MARK	DATE	REVISIONS	BY	CH'D	CCO#
1	08/08/11	W2 DUCT BANKS REINFORCEMENT	MG	RG	205

CONTRACT CHANGE ORDER NO._____
SHEET _____ OF _____

UTILITY PLAN

DETAILS
UTILITY PLAN
DUCT BANK PROFILE

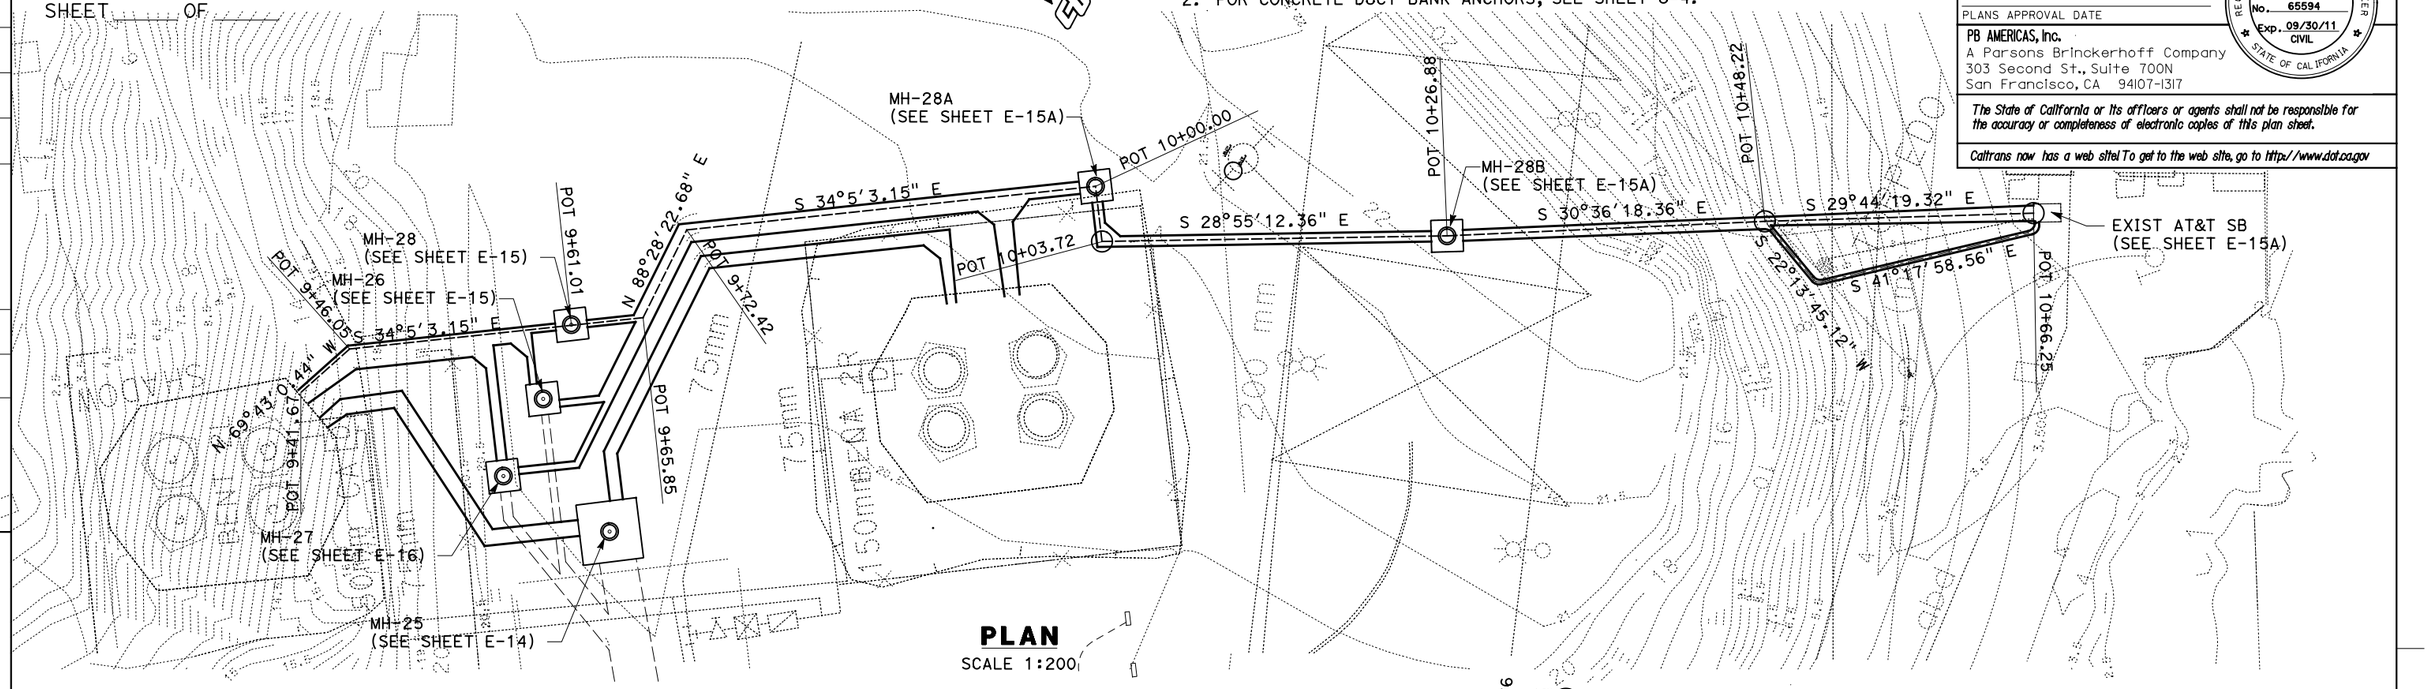
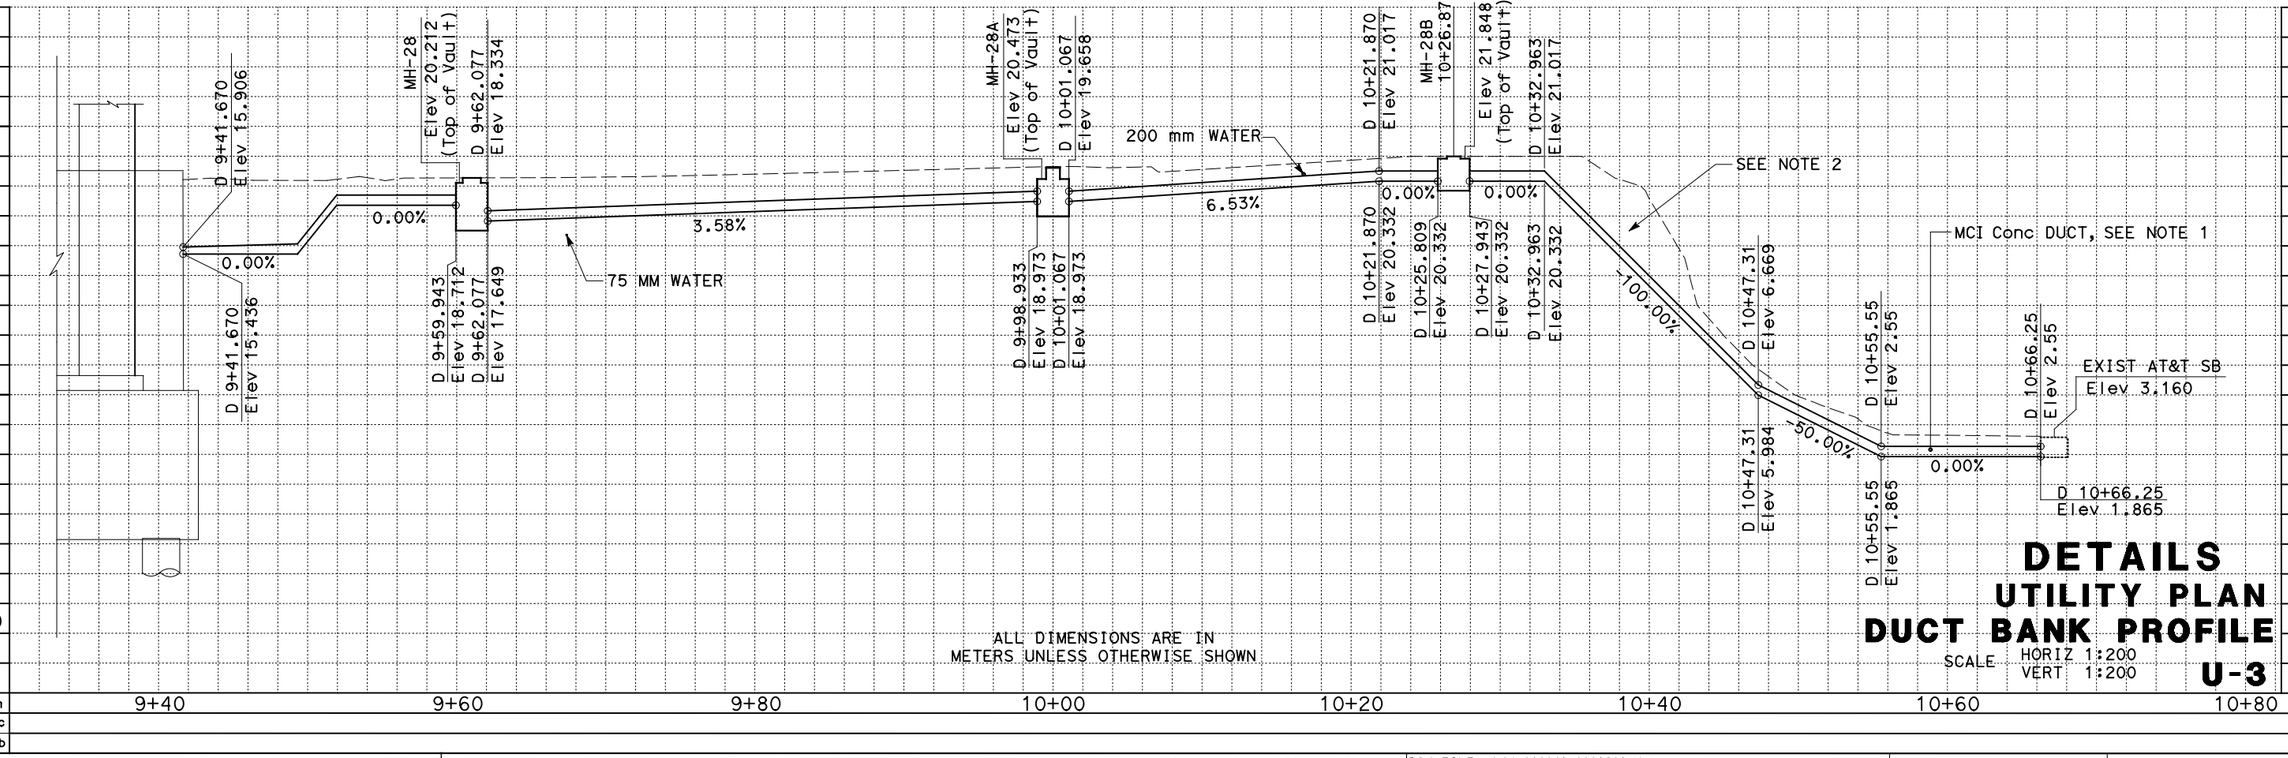
MARK	DATE	DESCRIPTIONS	BY	CH'D	CCO#
		REVISIONS			
0	08/08/11	W2 DUCT BANKS REINFORCEMENT	MG	RG	205

1. CONTRACTOR TO VERIFY LOCATION AND ELEVATION OF EXISTING DUCTS PRIOR TO CONSTRUCTION. IF EXISTING, ABANDONED MCI DUCT BANK IS IN CONFLICT, THE CONFLICTING PORTION MAY BE REMOVED.
2. FOR CONCRETE DUCT BANK ANCHORS, SEE SHEET U-4.

DETAILS
UTILITY PLAN
DUCT BANK PROFILE
SCALE HORIZ 1:200
VERT 1:200

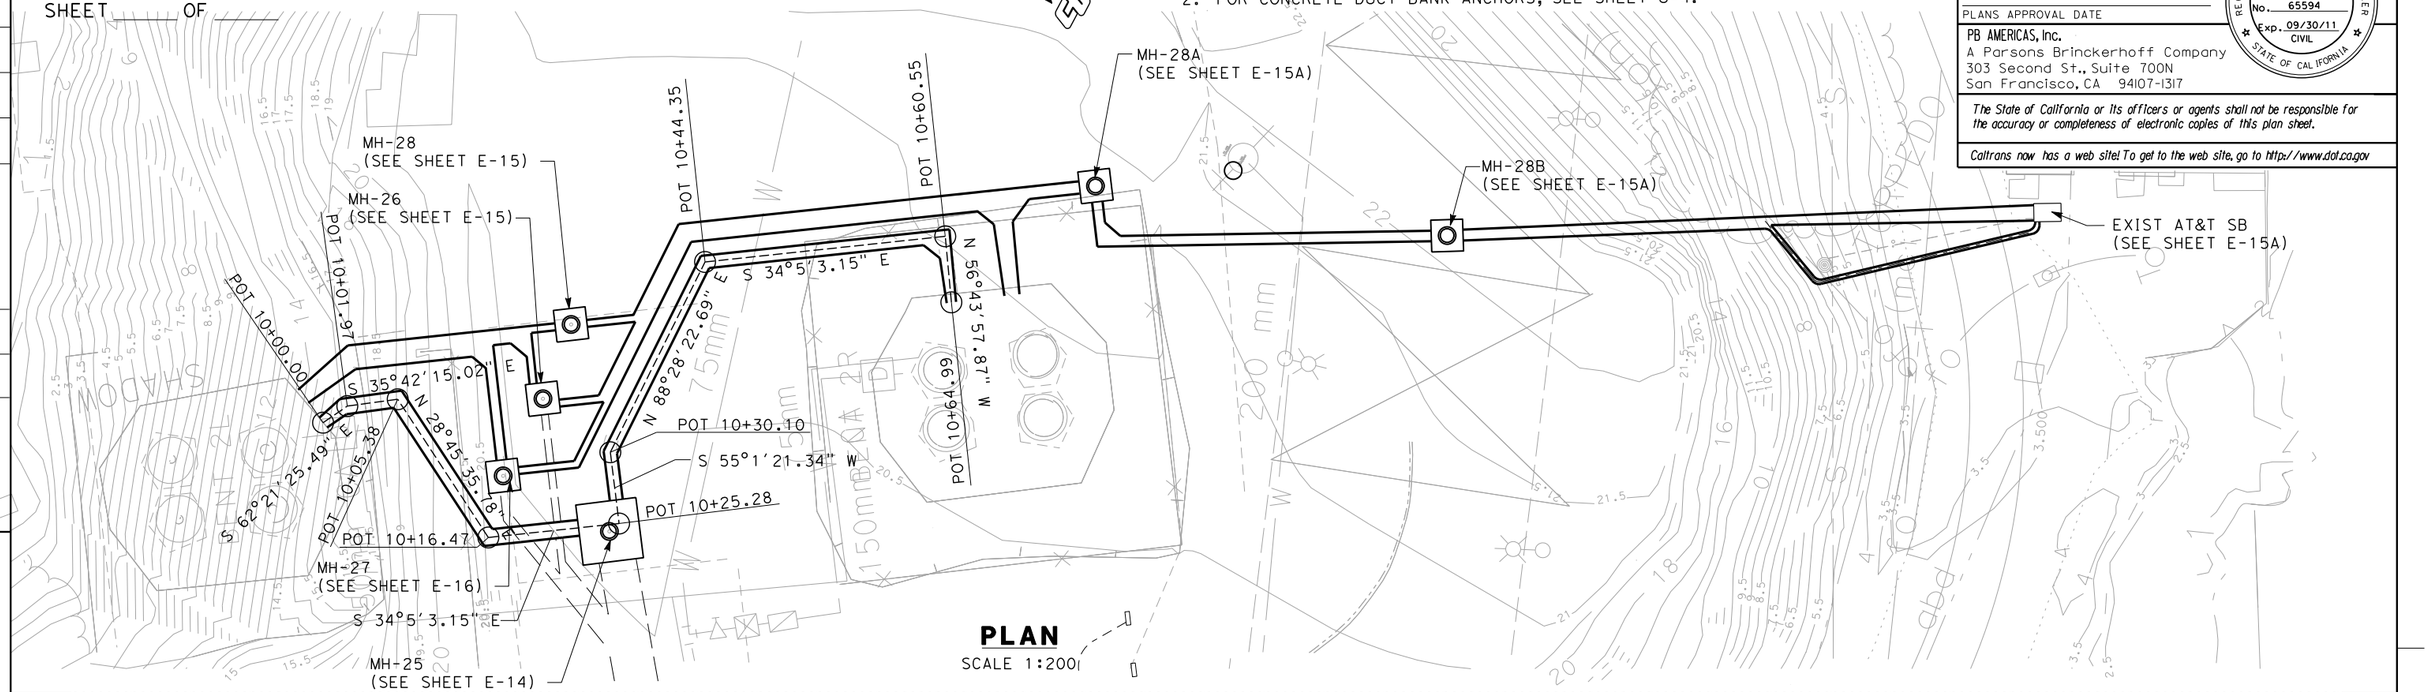
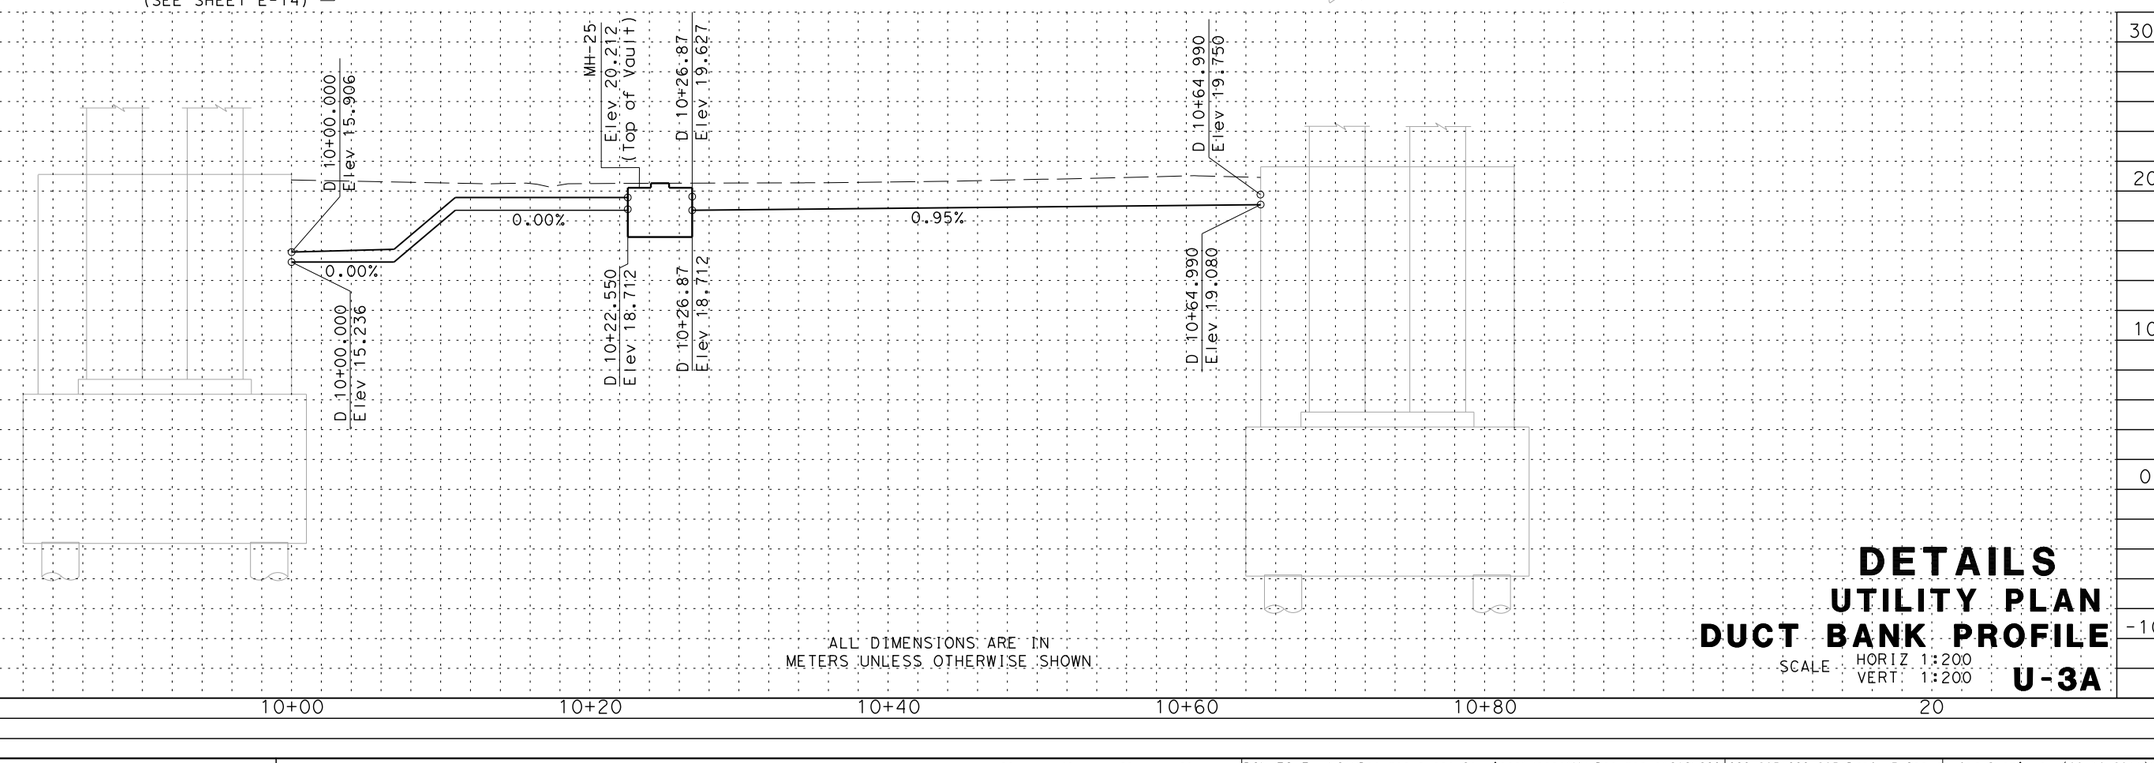
MARK	DATE	DESCRIPTIONS	BY	CH'D	CCO#
		REVISIONS			
0	08/08/11	W2 DUCT BANKS REINFORCEMENT	MG	RG	205

1. CONTRACTOR TO VERIFY LOCATION AND ELEVATION OF EXISTING DUCTS PRIOR TO CONSTRUCTION. IF EXISTING, ABANDONED MCI DUCT BANK IS IN CONFLICT, THE CONFLICTING PORTION MAY BE REMOVED.
2. FOR CONCRETE DUCT BANK ANCHORS, SEE SHEET U-4.

DETAILS
UTILITY PLAN
DUCT BANK STRUCTURAL DETAILS

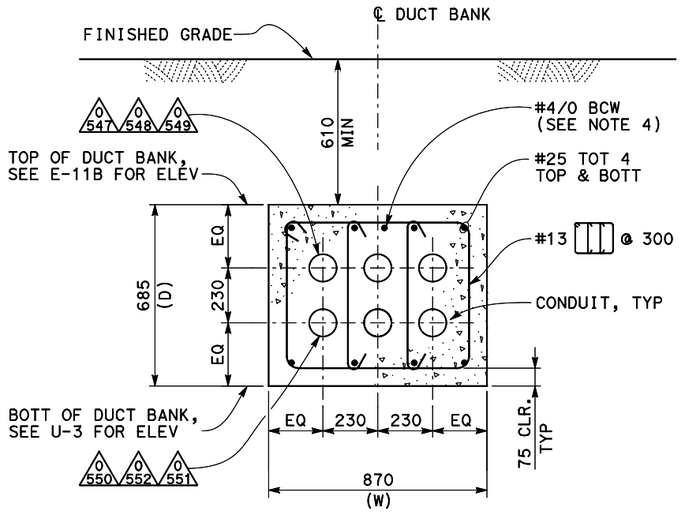
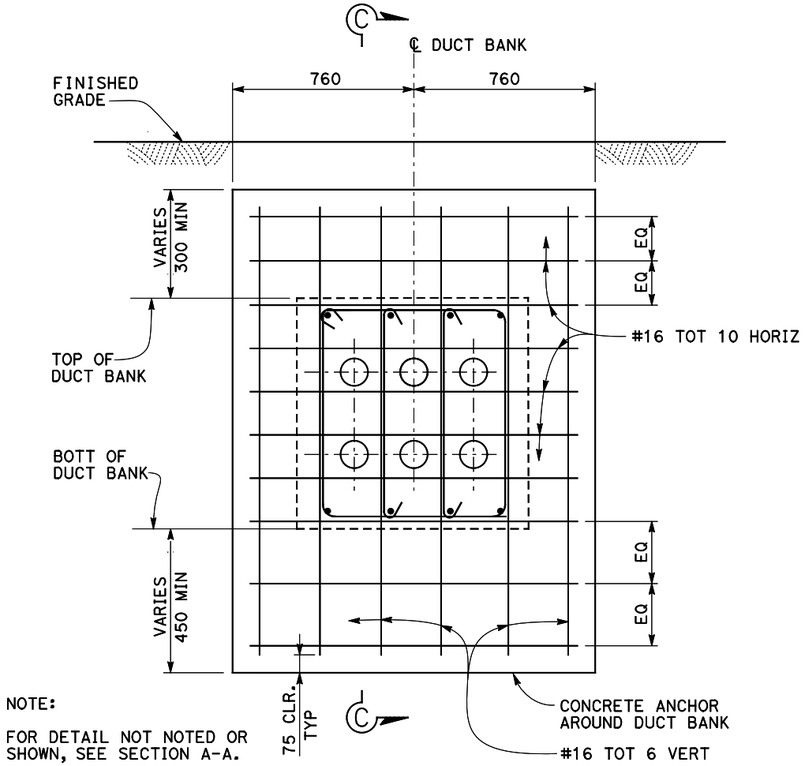
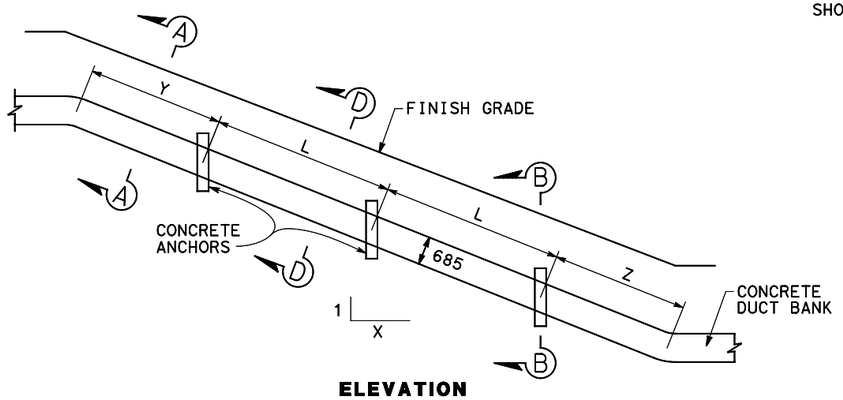
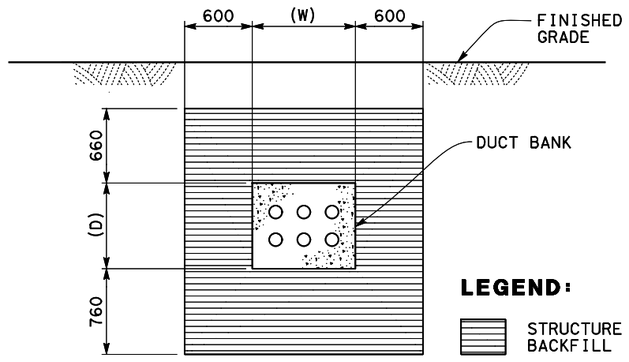
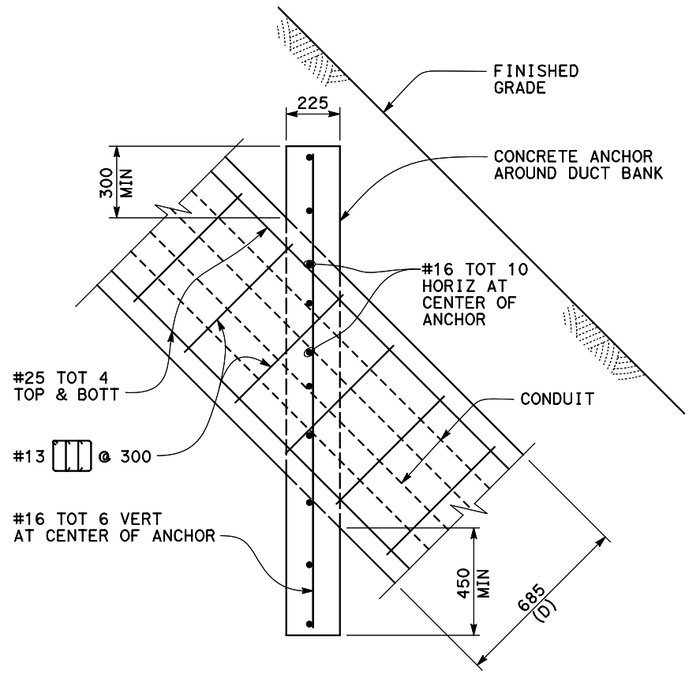
CONCRETE DUCT BANK ANCHORS (870 mm (W) X 685 mm (D))

1. SPACING OF CONCRETE ANCHORS FOR DUCT BANK SLOPES BETWEEN VALUES SHOWN IN TABLE A MAY BE INTERPOLATED.
2. CONCRETE ANCHORS ARE NOT REQUIRED AT DUCT BANK WHEN DUCT BANK SLOPE IS LESS THAN 1:3.
3. THE MAXIMUM LOADING ON DUCT BANK IS 280 kPa.
4. CONNECT GROUND CONDUCTOR TO GROUND BAR INSIDE MANHOLE.

REQUEST FOR INFORMATION NOT ADDRESSED IN THIS CCO REMAIN IN FORCE					
0	08/08/11	W2 DUCT BANKS REINFORCEMENT	MG	LJ	205
MARK	DATE	DESCRIPTIONS	BY	CH'D	CCO#
		REVISIONS

UNDERGROUND
DUCT BANKS AND MANHOLES
SCALE: 1:200

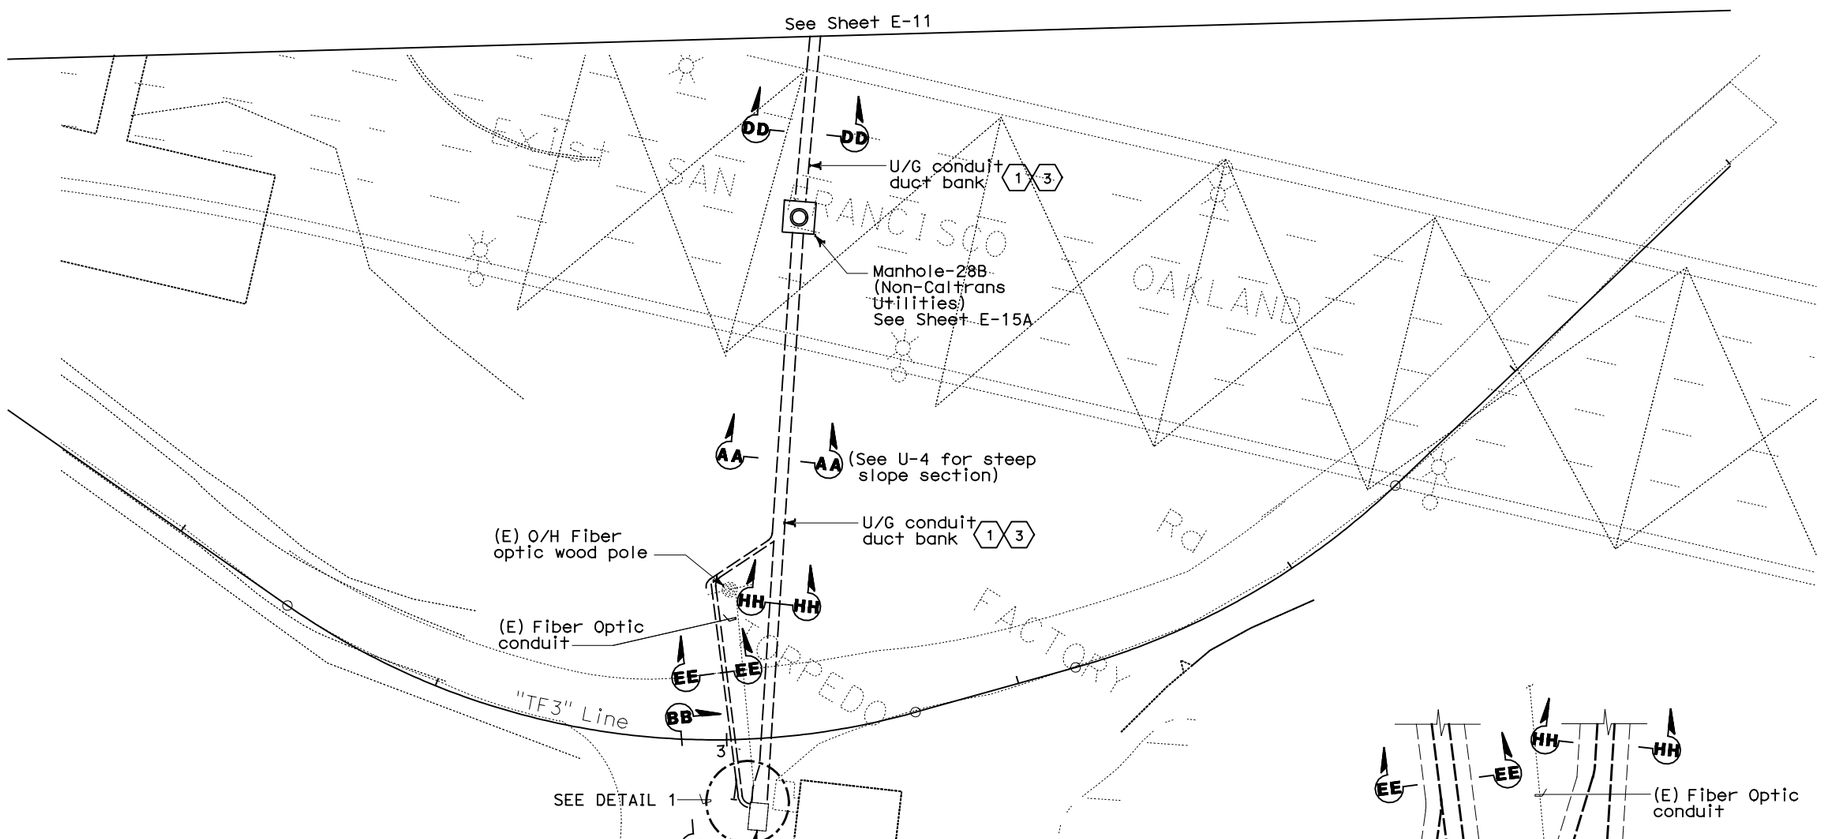
1. Contractor shall route duct bank with a minimum cover of 610 mm from top of conduit to top of finished grade. The conduit bank shall slope down to manhole. Verify existing to avoid interferences. Connect the ground conductor to the existing grounding grid at the end of duct bank.
2. Contractor to clean and drain (E) AT&T SB. Contractor shall use existing provisions for conduit entries to AT&T SB. Other conduit penetrations are not shown
3. The conduits from manhole MH-28A to AT&T Hut manhole shall be rigid pvc schedule 40. Conduit 90 degree bends, riser and exposed to grade shall be rigid galvanized steel conduit.

REQUEST FOR INFORMATION NOT ADDRESSED IN THIS CCO REMAIN IN FORCE					
0	08/08/11	W2 DUCT BANKS REINFORCEMENT	EJL TW	RG	205
MARK	DATE	DESCRIPTIONS	BY	CH'D	CCO#
REVISIONS
